SERVICE BULLETIN

Service Bulletin No.: DA20-32-02 Rev 0

Title: Nose Gear Fork, Fatigue

Figure 1

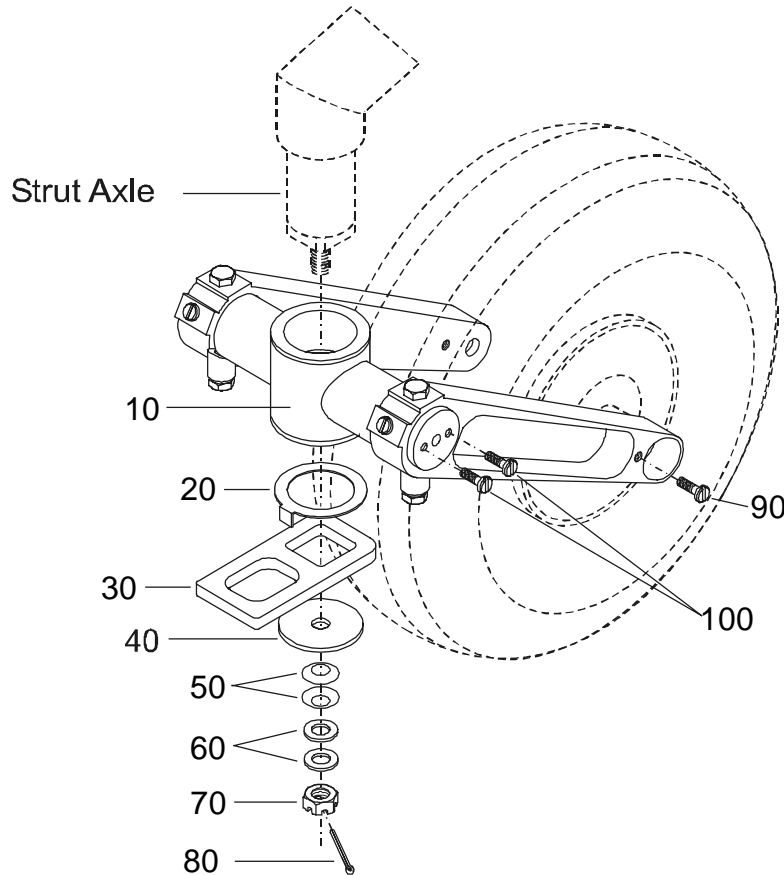
- 10.2.8** Install new fork assembly – refer to Figure 1 for assembly order.
- 10.2.9** Tighten pivot nut until a Breakout Force of 30 – 50 N (6.75 – 11.25 lbs.) is achieved in both directions along the axis of the axle (Figure 4).

Figure 3

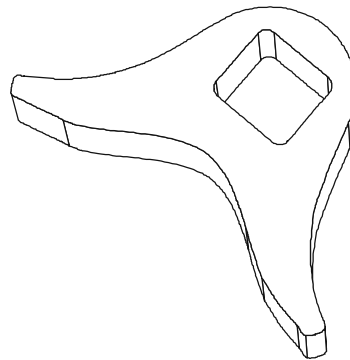
1. **ATA Code:** 3220
2. **Effectivity:** DA20-A1 aircraft.
3. **General:** As a result of hard landings, cracks have appeared in the nose landing gear fork of some aircraft. This service bulletin is divided into two parts. Part 1 addresses an inspection of the Nose Gear Fork. Part 2 addresses modifications required to remove the Nose Gear Fork and replace it with an optional heavy duty fork.
Note: Diamond Aircraft recommends an upgrade of the Steering Stop Plate to P/N 20-3220-00-23 (ITEM 30 in Figure 1) in place of P/N 20-3220-00-18 (see Figure 3) installed on some aircraft, before accomplishment of Part 2 of this service bulletin.

P/N 20-3220-00-18
Steering Stop Plate
Fitted to some aircraft.
